ADDENDUM TWO

Reference: RFP #735-16-8163 Legacy Hall Landscaping

Project: Midwestern State University
New Residence Hall
Site Improvements - Bid Package 02

Addendum No.: 02

NYLOPLAST RISER EXTENSION: 29 __ AG

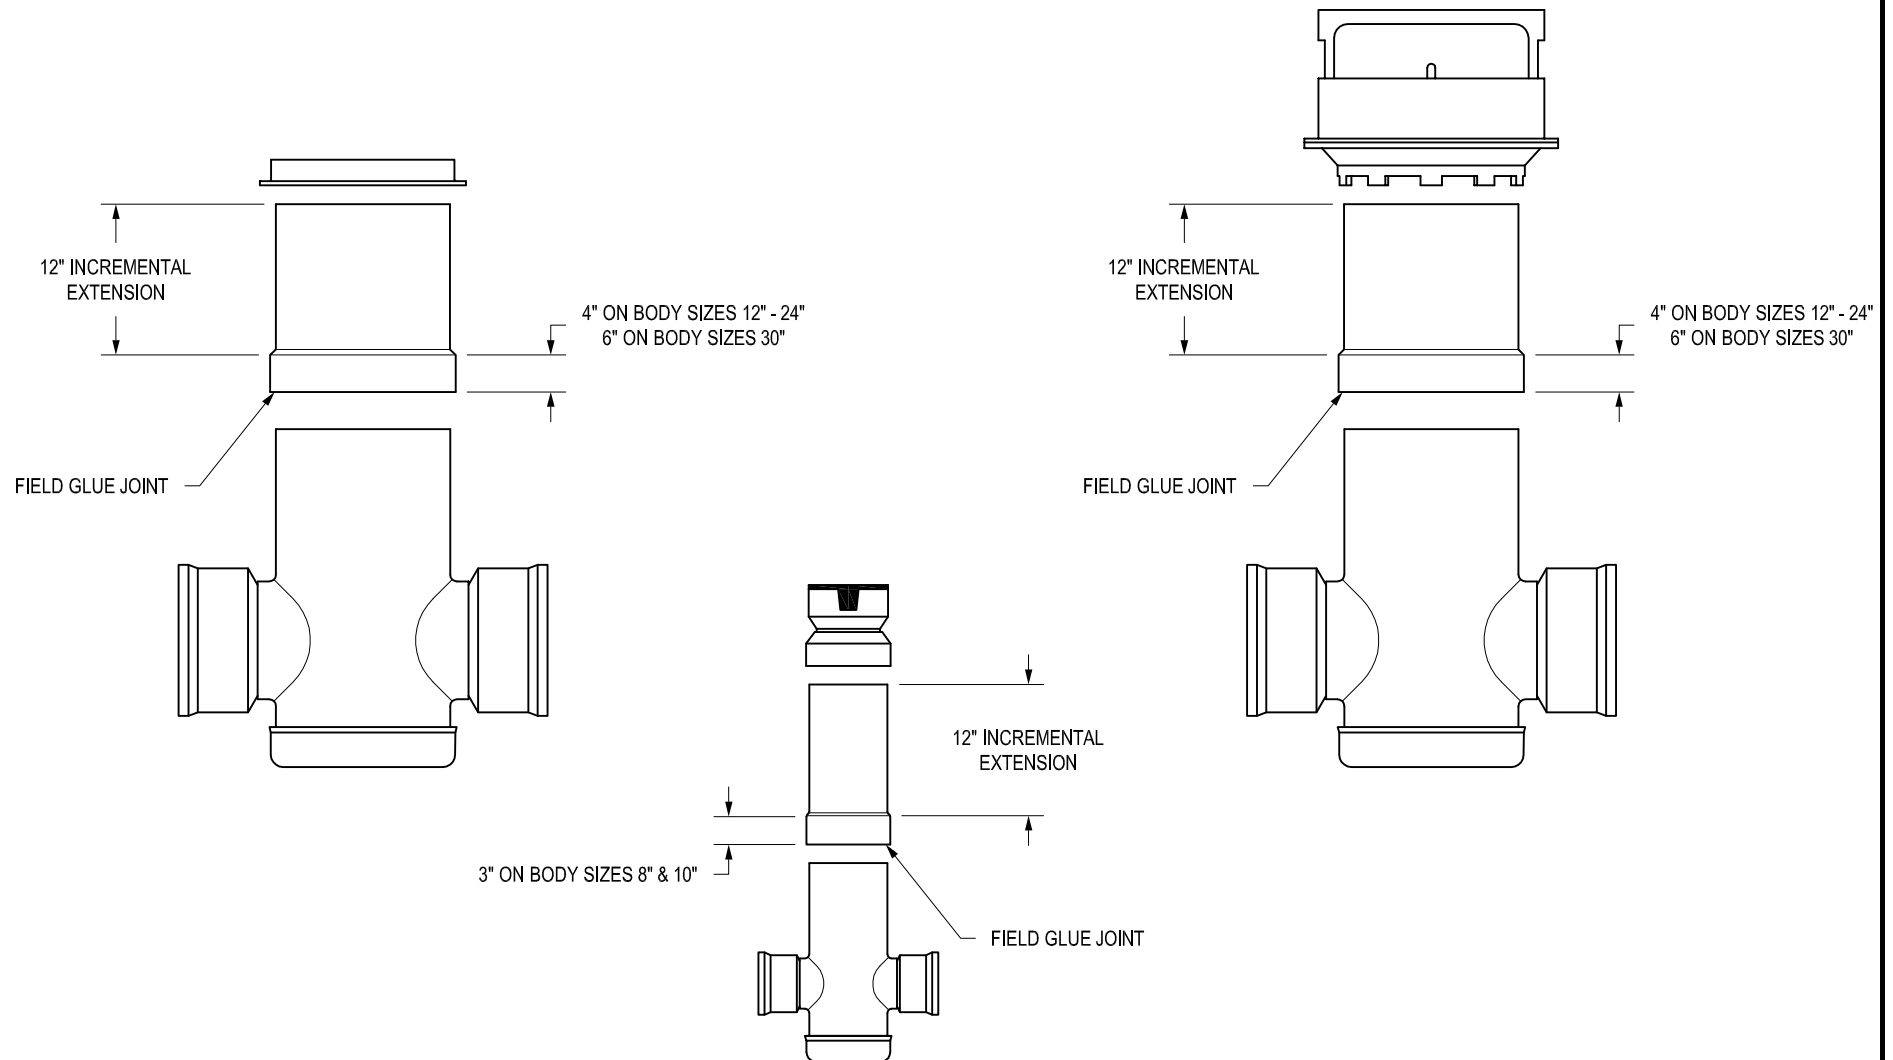
1. C102 – Site Grading Plan (Attachment) is included “For Reference Only” to provide the following information:
 - a. Final finish grades
 - b. Location of storm water inlets that will require riser extensions to meet final finish grades.
2. PROVIDE and INSTALL the following storm water riser extension drains at all storm water inlets as indicated on C102 to meet final finish grades:
 - a. Nyloplast, 8in-30in Riser Extension. (Cut Sheet Attached). Size extension per already installed storm water riser and grates.
3. CLARIFICATION: Landscape contractor to provide 4” of topsoil across the entire project site. Topsoil is to meet the performance specifications of Section 32 9200 Turf and Grasses.

L100.02

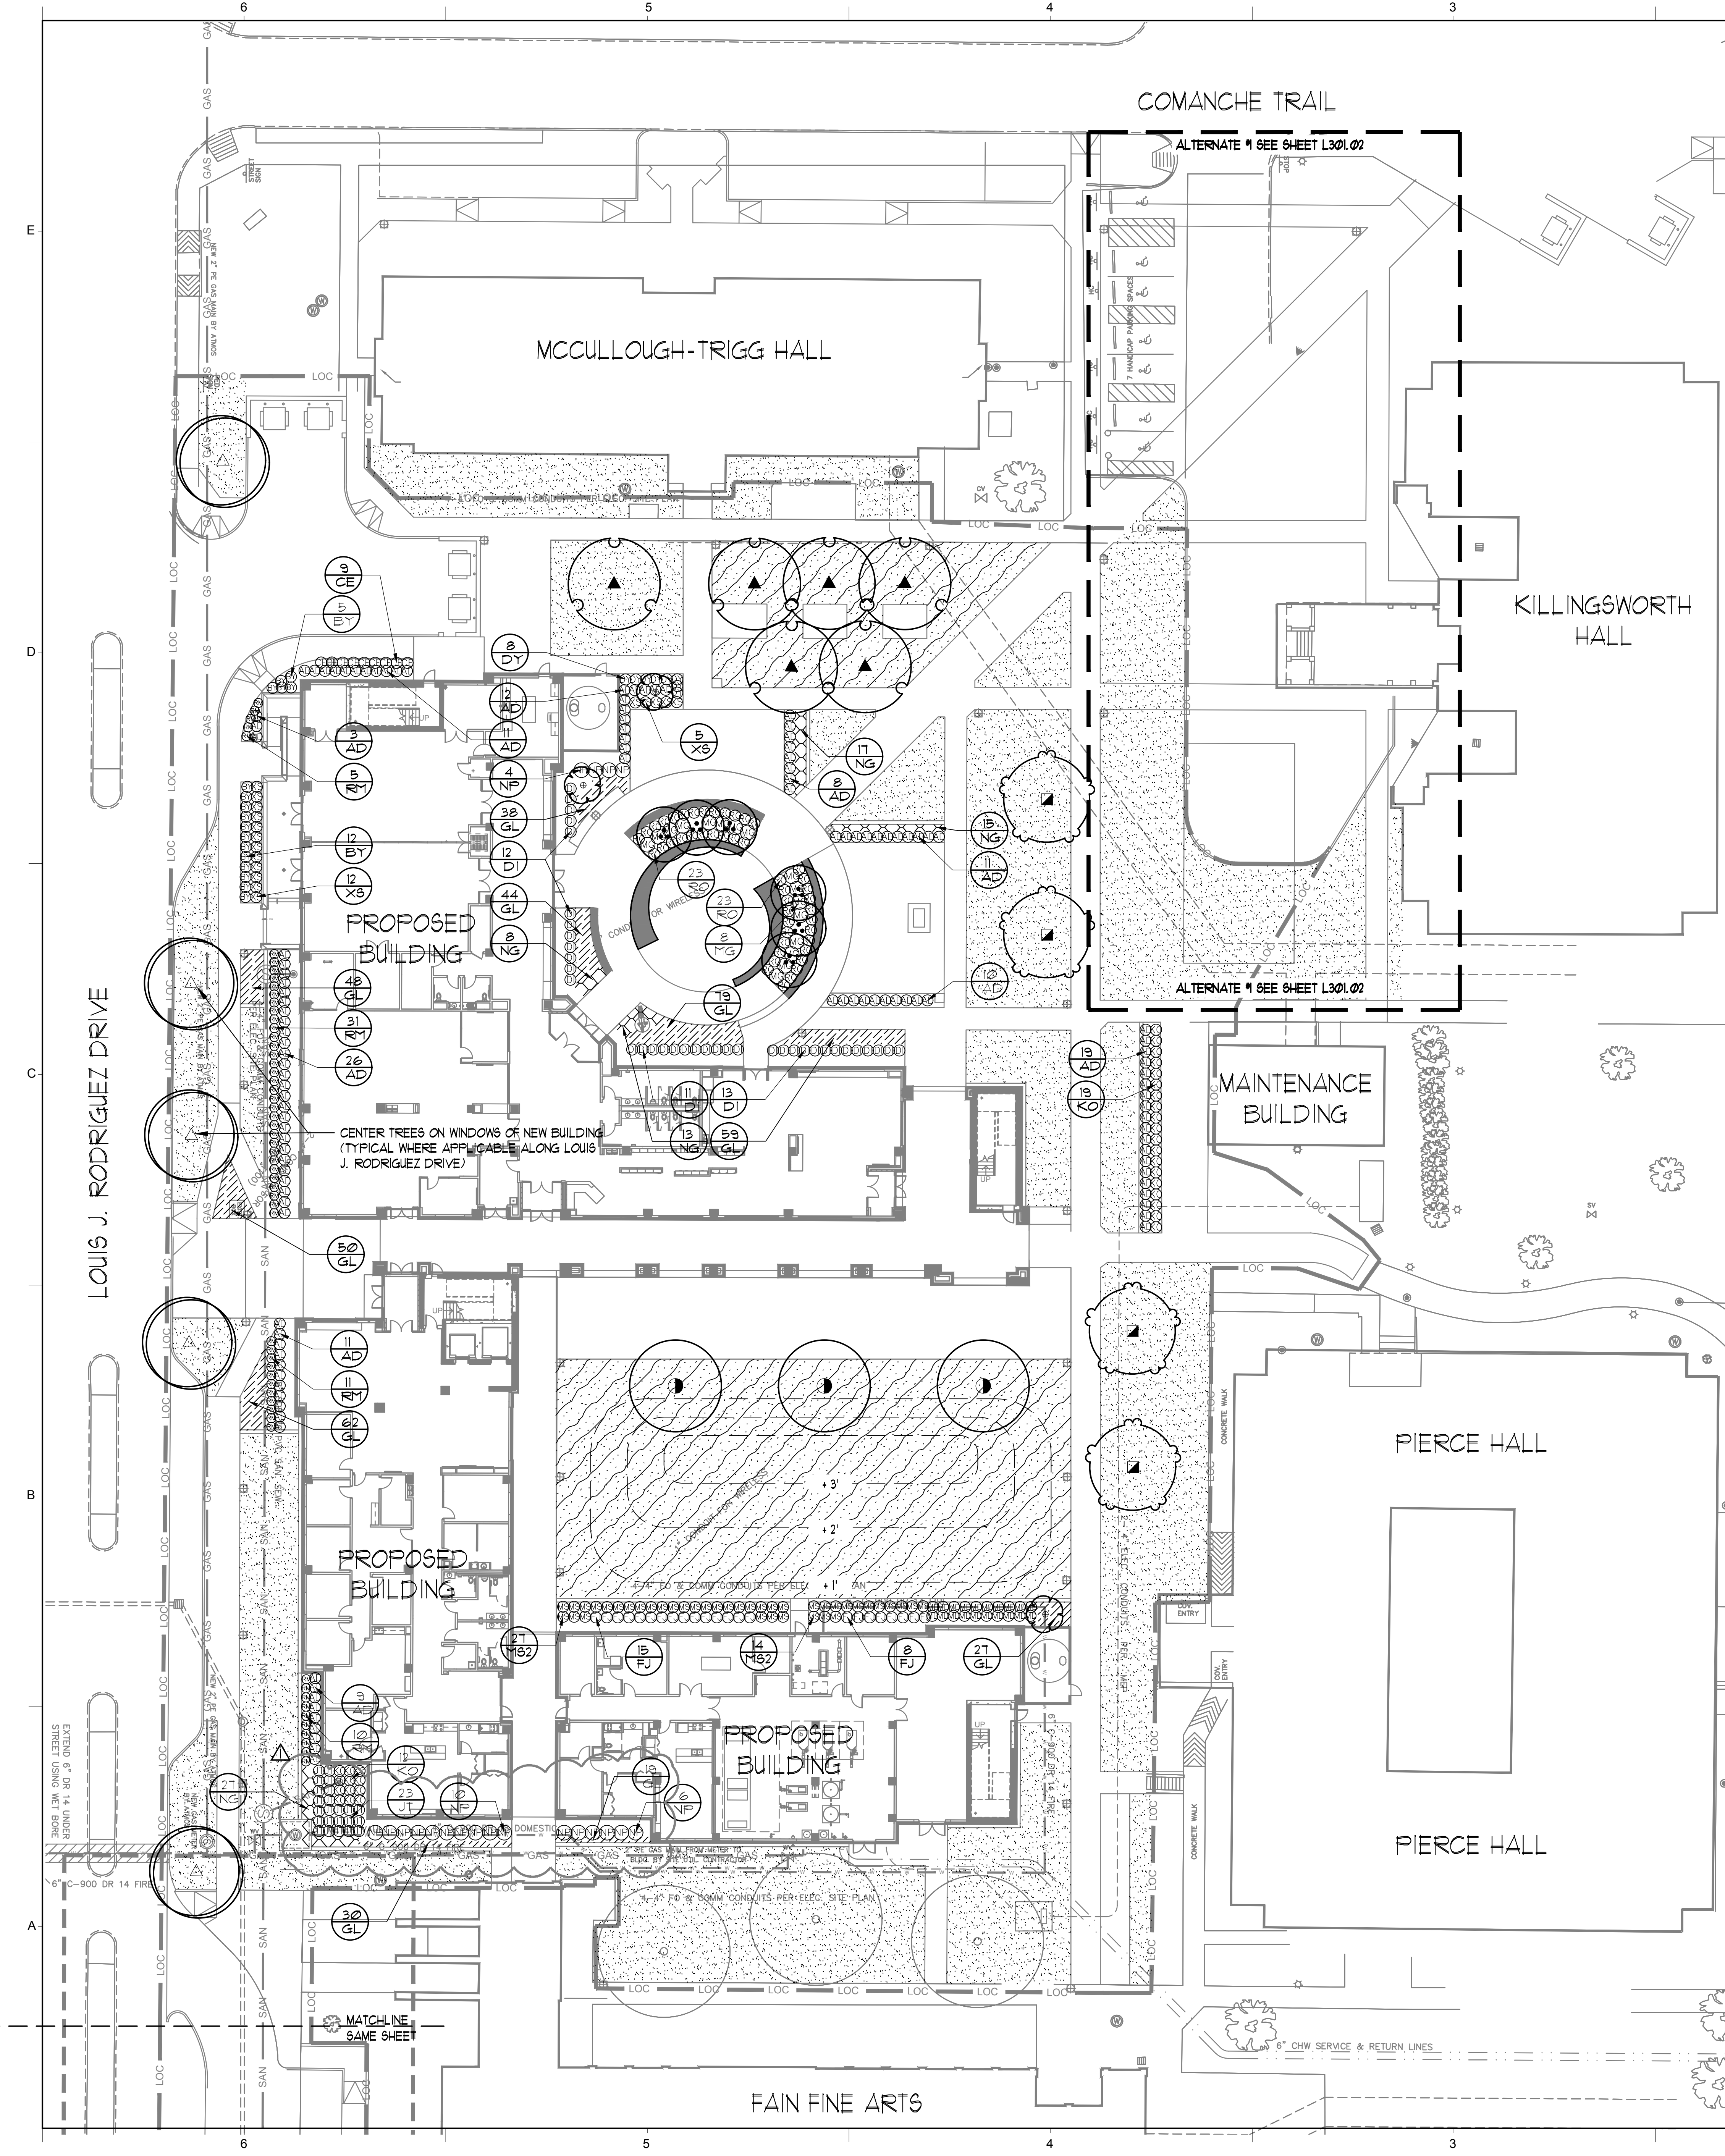
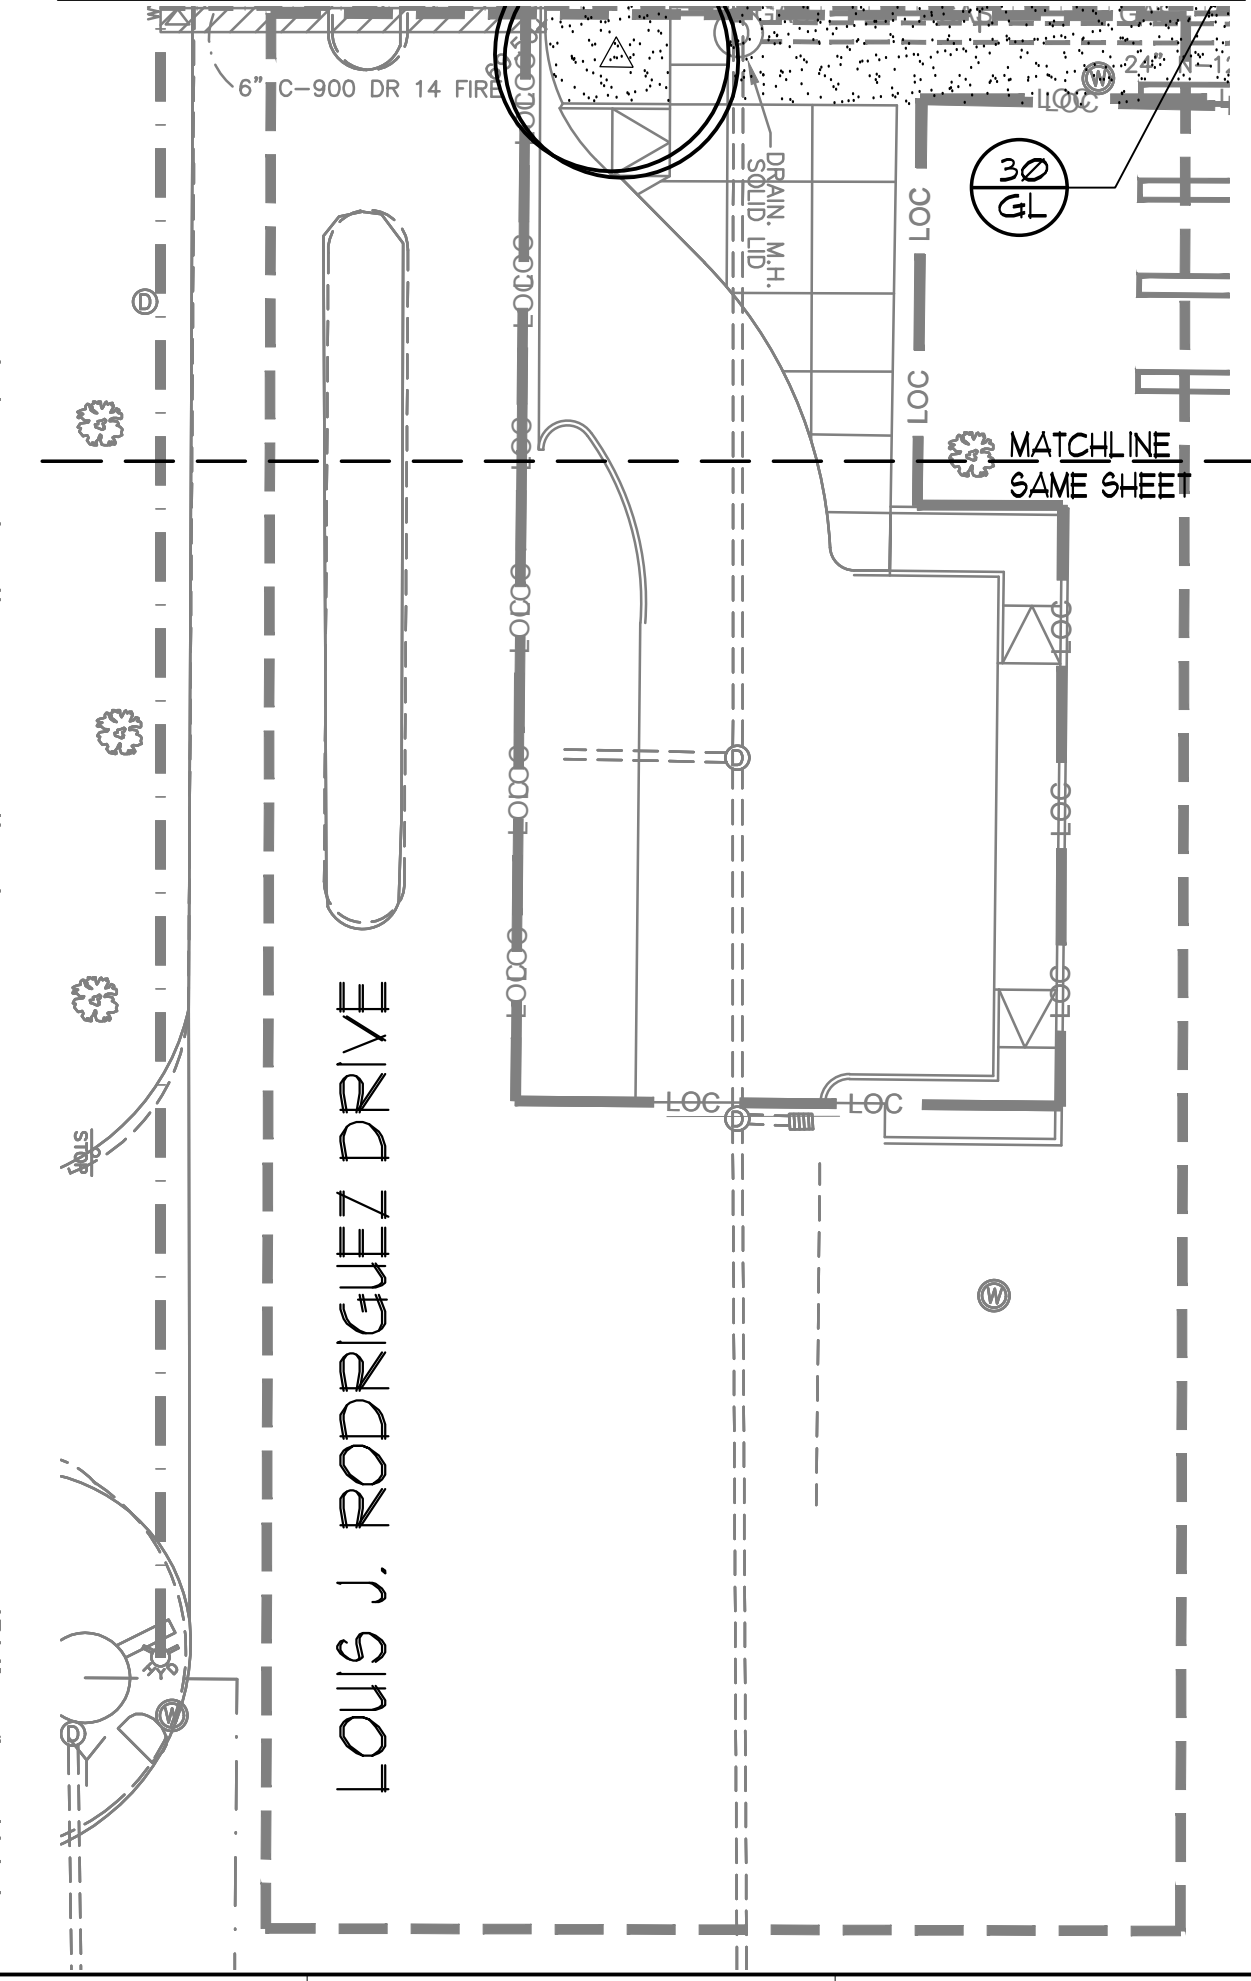
- A. REPLACE Sheet L100.02 with the following Sheet L100.02, Rev 1. Changes to the sheet include the following:
 1. Modified quantity of shrubs and groundcover.
